OUR REF: 18230 – S4.55

22 March 2023

**RE: SECTION 4.55 MODIFICATION FOR DEVELOPMENT APPLICATION (DA NO. 2019/0916
NO. 32 BOWER STREET, MANLY**

Figure 3: Approved and Proposed Basement Floor Plan

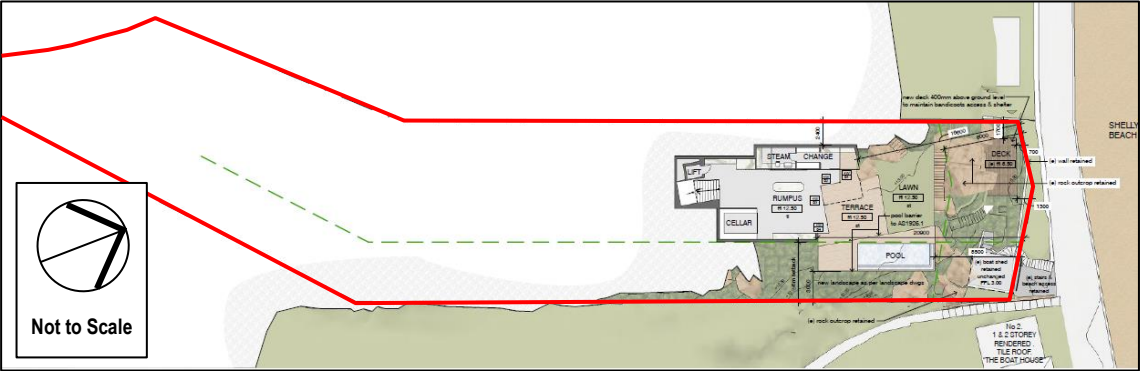
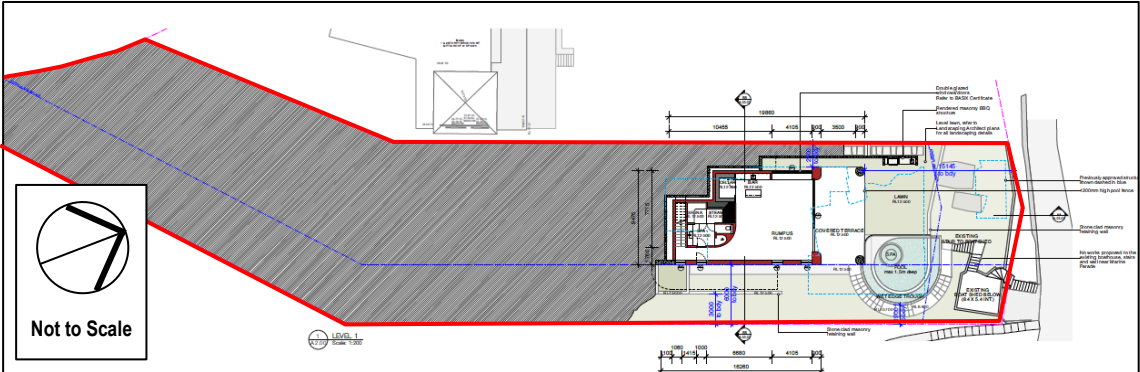
The Approved Dwelling's Basement Floor Level was at RL 12.50 AHD and comprised Lift and Stair access to Upper Levels; Cellar; Steam Room; Change Room; a Rumpus Room and adjacent Terrace; Lawn area and Swimming Pool.

The Proposed Modification's Basement Floor Level remains at RL 12.50 AHD and comprises Stair access to Upper Levels; Cellar; Sauna and Steam Room; Bath Room; a Rumpus Room and adjacent Terrace; Lawn area and Swimming Pool (see **Figure 3**).

Figure 4: Approved and Proposed Lower Ground Floor Plan

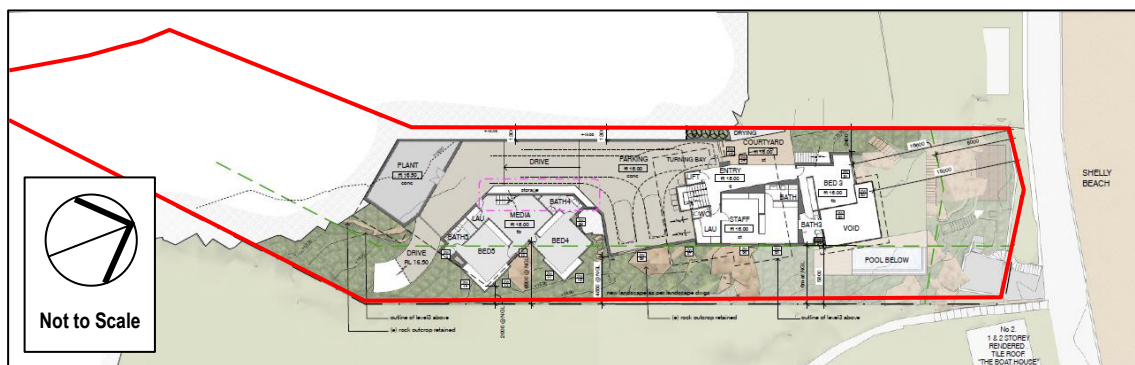
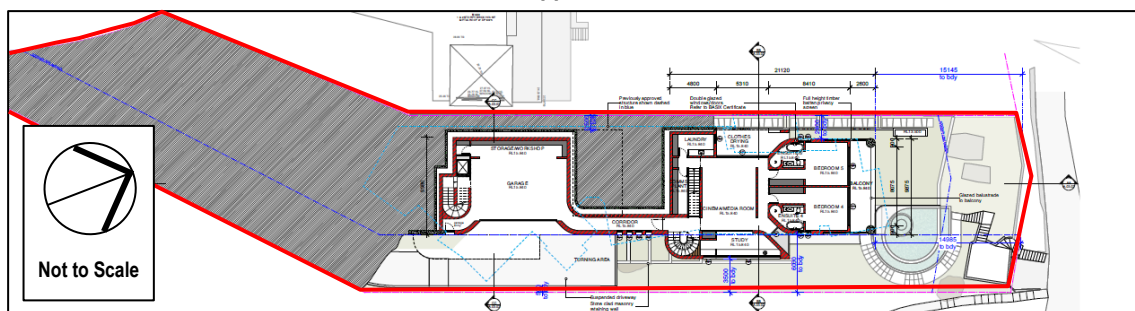
The Approved Dwelling's Lower Ground Floor Level was at RL16.00 AHD and RL 16.50 AHD. The room uses include two Bedrooms with En-Suites, a Laundry, Media Room with stair access to the Ground floor; a double Garage accessed via a driveway; and separate Staff Accommodation including two Bedrooms, two Bathrooms, a Laundry, Stairs to the upper level, and a separate Entry.

The Proposed Modification's Lower Ground Floor Level is at RL 15.84 AHD and has relocated the garage closer to the reconfigured driveway. The two Bedrooms, En-Suites, Laundry, and Media Room have relocated to the northern end, with a Balcony added to the Bedrooms. A Study and a Drying Room have been added. The staff accommodation is not required by the current owners and has been deleted (see **Figure 4**).

Figure 5: Approved and Proposed Ground Floor Plan

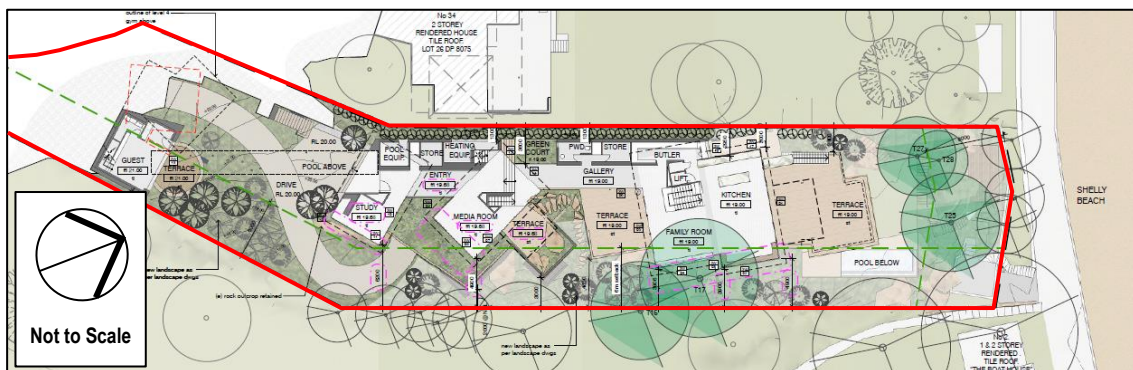
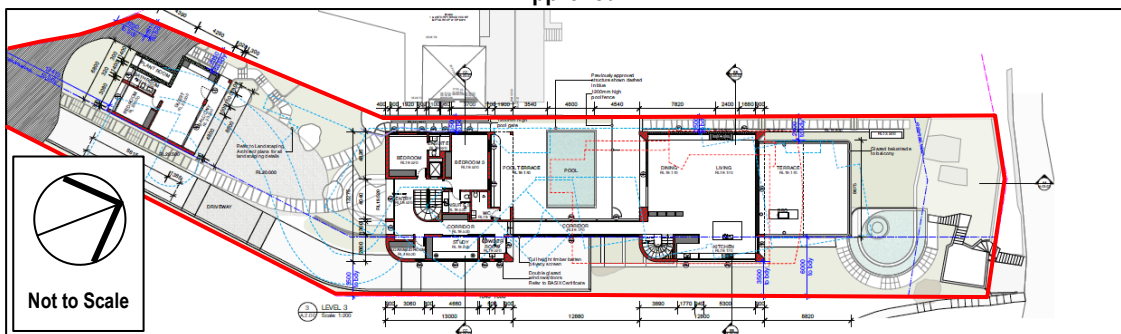
The Approved Dwelling's Ground Floor Level Guest Accommodation with Bathroom was at RL 21.00 AHD. The main dwelling Entry, Study, and Media room portion was RL 19.68 AHD. The Family Room, Kitchen, Butler's Pantry, Gallery, Powder Room, and Storeroom to the north were at RL 19.00 AHD

The Proposed Modification's Ground Floor Level is at RL 19.17 AHD & RL 19.52 AHD; and RL 23.00 AHD for the Guest Accommodation. The Guest accommodation has a Bedroom, Bathroom and Living area. The Ground Floor level has two Bedrooms; each with En-Suite; a Mud Room; a Powder Room; Lift & Stair access to other levels; Pool Bathroom; Swimming Pool; Corridor to combined Living, Dining & Kitchen, adjacent to a large, partially covered Terrace (see **Figure 5**).

Figure 6: Approved and Proposed First Floor Plan

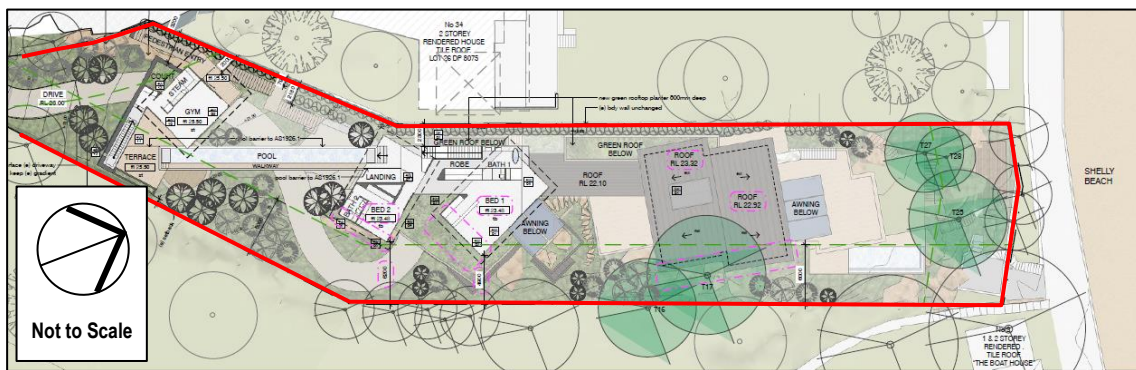
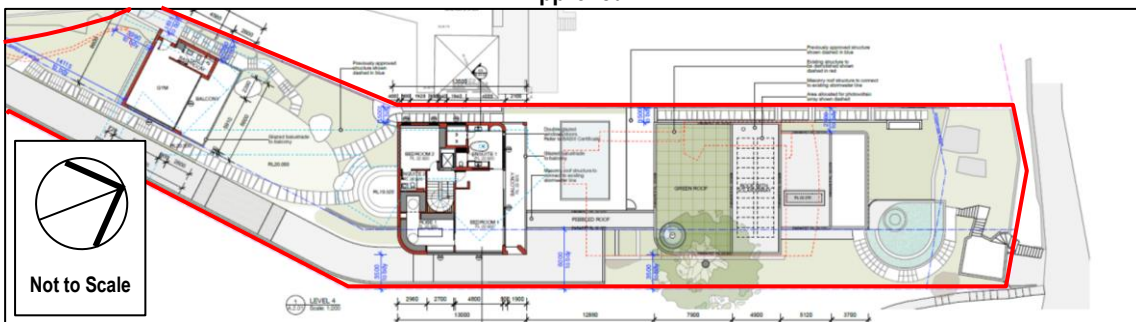
The Approved Dwelling's First Floor Level was separated into three elements, connected by a lap pool and walkway. The Gym area was at RL 25.50 AHD and the landing area and adjoining rooms were RL 23.48 AHD. In this area was a Master Bedroom Suite with Bedroom, En-suite and Walk-in Robe; and a second Bedroom with has En-suite; and Stairs to lower levels.

The Proposed Modification's First Floor Level is at RL26.30 AHD for the Gym; and RL 22.92 AHD for the Master Bedroom. The Gym has a large room with En-Suite and a north-facing balcony. The Master Bedroom Suite has a Bedroom, En-suite and Walk-in Robe, with balcony adjoining; and a second Bedroom with has En-suite; and Lift and Stairs to lower levels (see **Figure 6**).

Figure 7: Approved and Proposed Roof Plan

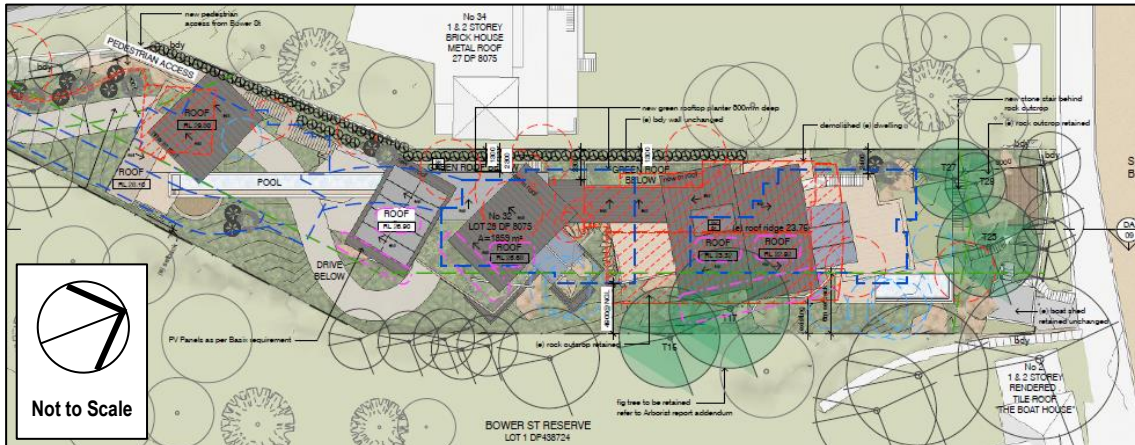
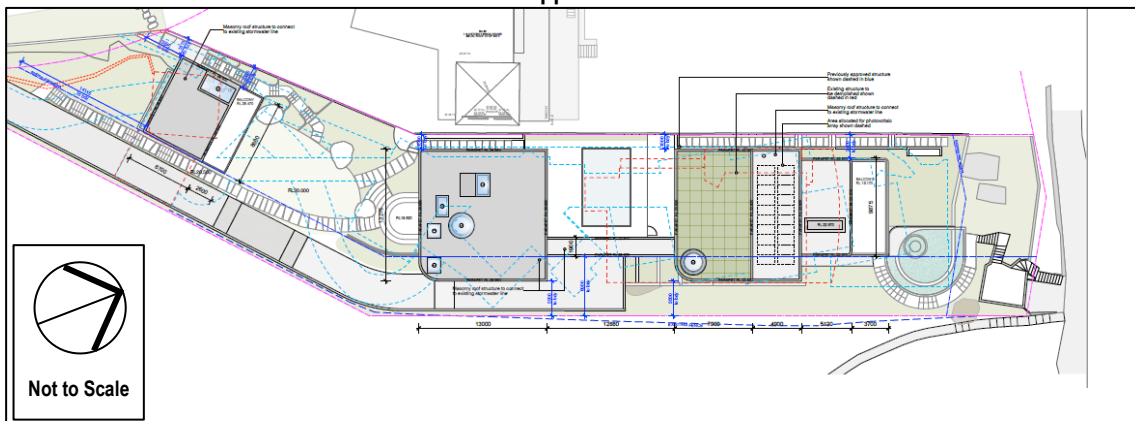
The Roof Plan does not exceed the approved roof levels of the original approval, and where two roof levels applied, the lower level is the roof level maintained. The approval had four main roof elements, which has been consolidated to three main elements.

The southern roof was approved and remains at RL 29.80 AHD. The central roof was approved at RL 26.90 AHD & RL 26.68 AHD, and RL 26.68 AHD is proposed. The northern roof was approved at RL 23.32 AHD & RL 22.92 AHD, and RL 22.92 AHD is proposed (see **Figure 7**). The proposal includes a non-trafficable roof garden over the northern roof, for improved outlooks from the subject site and neighbours.

Figure 8: Height Blankets showing Approved and Proposed Building Heights

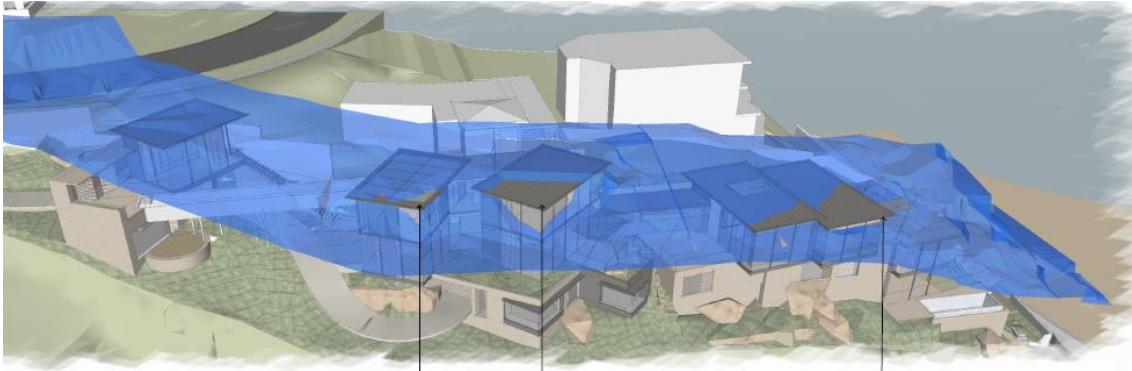
The overall maximum height is lower than the approval, at 10.78m, compared to 10.89m. On such a complicated site with varying levels throughout, a significant fall from front to rear and steeply sloping cross falls from west to east, Council previously accepted that height compliance would be difficult to achieve on the eastern part of the site.

As noted, the lower heights for pavilions have been utilised in this modification, and the pavilions are proposed to be parallel to the eastern boundary. Thus, ground levels have varied beneath the relocated pavilions, compared to the approval (see **Figure 8**, on the following page).

Most importantly, the RLs are not increased, and in the case of the Master Bedroom suite, the roof RLs have been lowered.

Figure 9: Reduction from Existing and Approved to Proposed Areas over 6m Setback within 6m Setback Zone

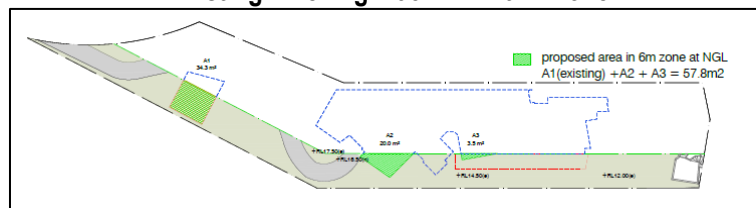
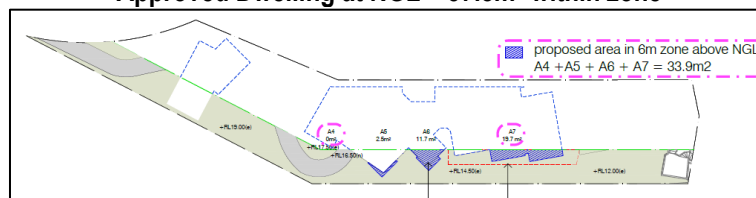
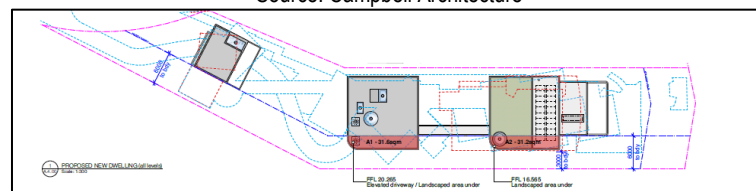
The existing dwelling and garage encroached on the DCP's 6 metre setback to the adjacent Reserve by 95.2m². This was reduced to 91.7m² in the current approval, but would be further reduced by 28.9m² to only 62.8m² within the setback zone. Furthermore, the two areas of intrusion are elevated which allows landscaping beneath the northern element and the driveway, beneath the southern. The approved gym/guest accommodation is relocated to the west and therefore, there is no longer an encroachment closer to Bower Street (see Figure 9). The modification has improved the situation.

Existing Dwelling – 95.2m² within zone

Approved Dwelling at NGL – 57.8m² within zone

Approved Dwelling at Above NGL with Landscape Under – 33.9m² within zone

Total: 91.7m² within zone

Modifications Above NGL: 62.8m²

Figure 10: Approved & Proposed Western Elevation

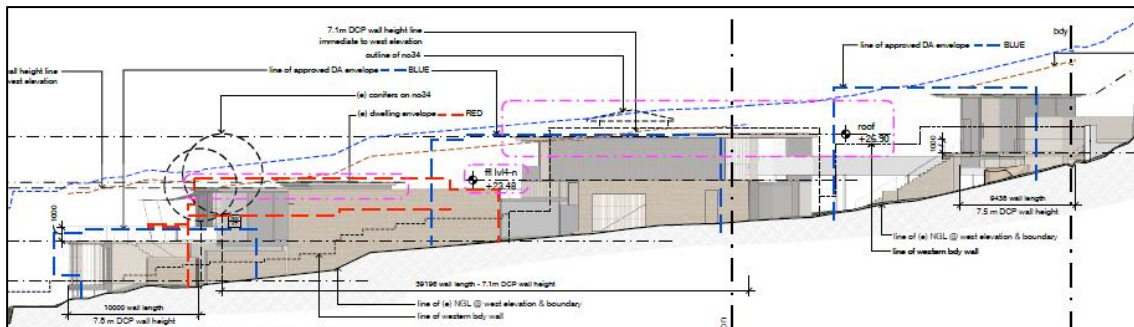
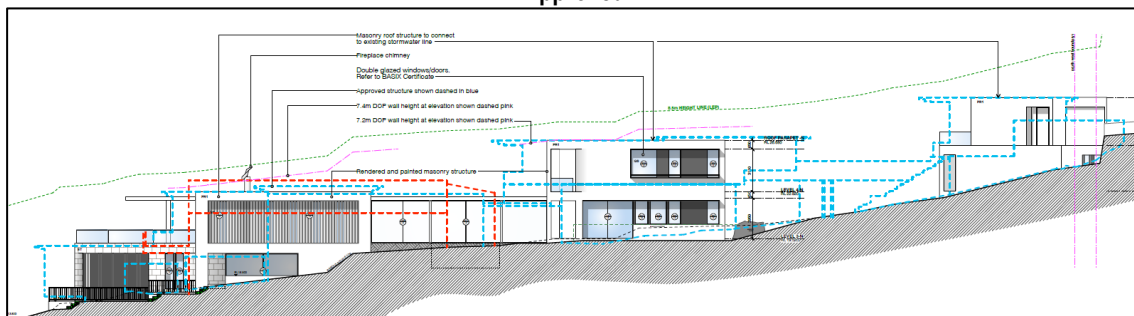
The wall heights on the proposed western elevation are lower than the approved wall heights (see **Figure 10**), and exclude the 600mm allowance for parapets, as outlined in DCP Section 4.1.2.3 Roof Height, sub-section (b).

Proposed**Figure 11: Approved & Proposed Eastern Elevation**

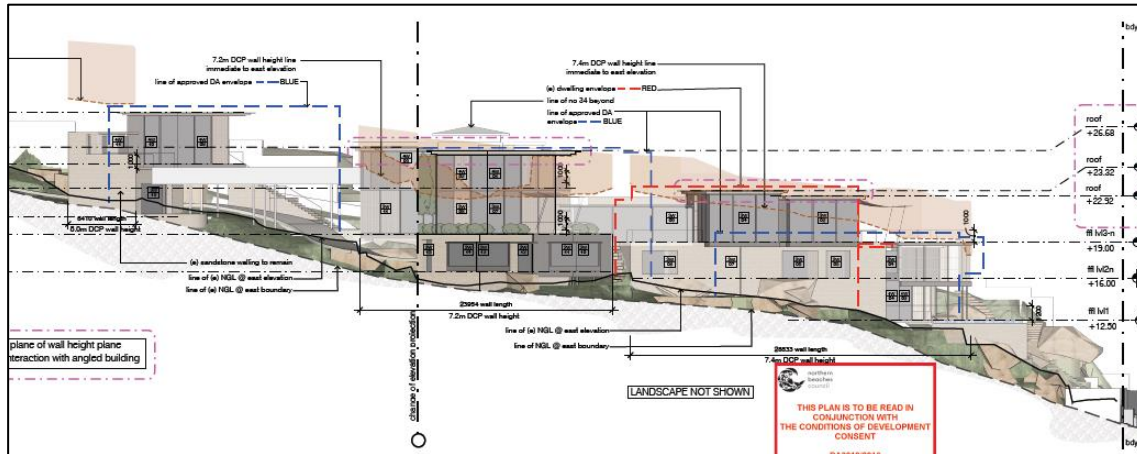
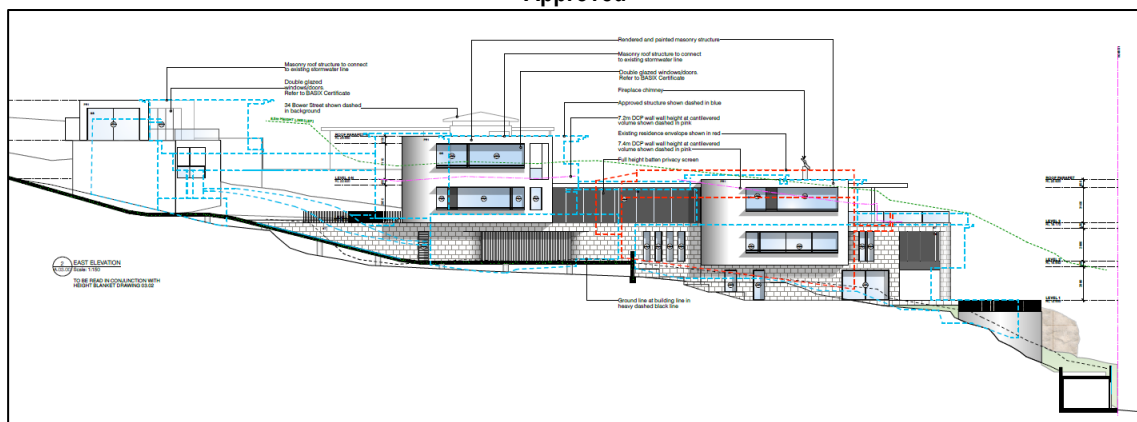
On the eastern elevation, a direct comparison is more difficult as the approval features angled pavilions, whereas the proposal is parallel to the boundary. Excluding the 'point', **Figure 11** (on the following page) shows a very similar level of wall height departure on this elevation.

Nevertheless, the living room portion is very much the same as the approved departure for wall height.

With respect to the gum/guest pavilion, both the approval and the proposed modification complied with wall height requirements, being well below the limits.

Sources: Campbell Architecture & Eaton Molina Architecture
Figure 13: Minor Changes to Shadow Diagrams – 21 June

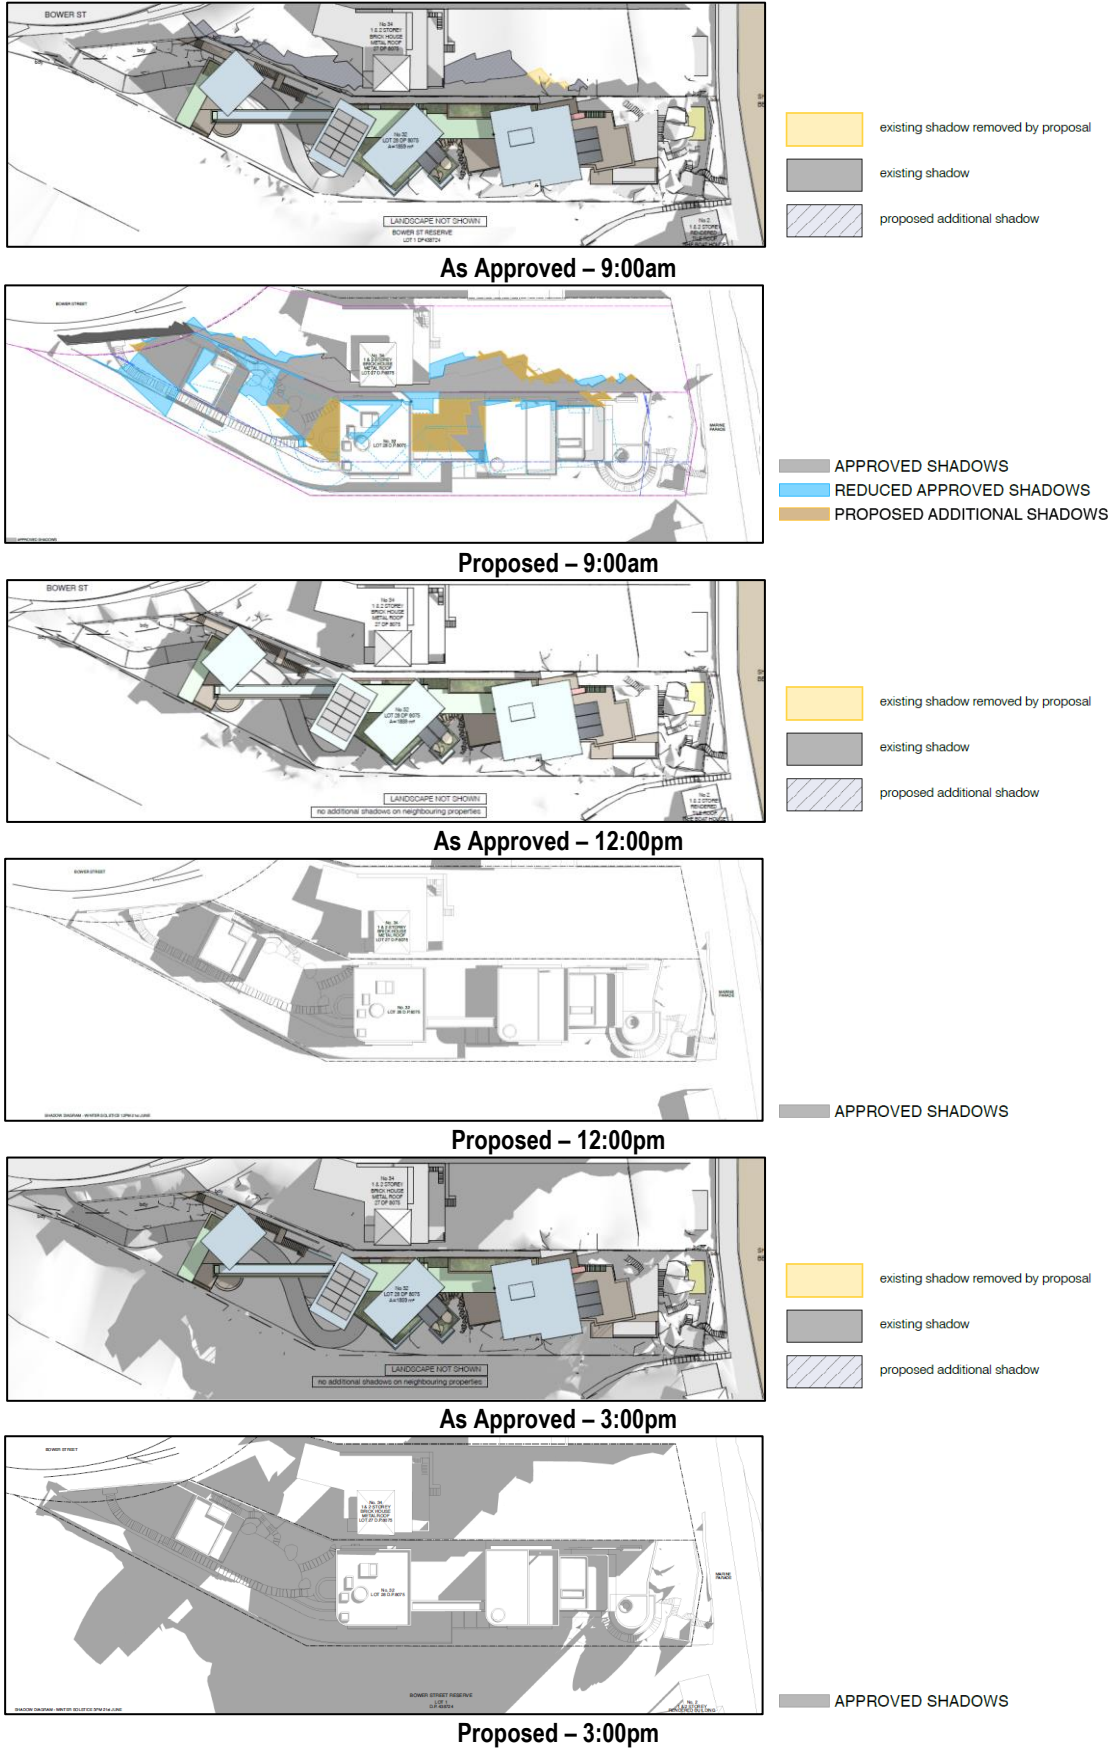
The modifications' changes through consolidation of pavilions have increased the setbacks to the neighbouring dwelling. The lowered roof heights have reduced the overshadowing effects to the neighbours at 9:00am on 21 June, and moved the shadows further north on the site (see **Figure 13**, on the following page). There is no effect on neighbours at 12:00pm and the shadows are similar at 3:00pm to the approval, falling on the heavily vegetated reserve.
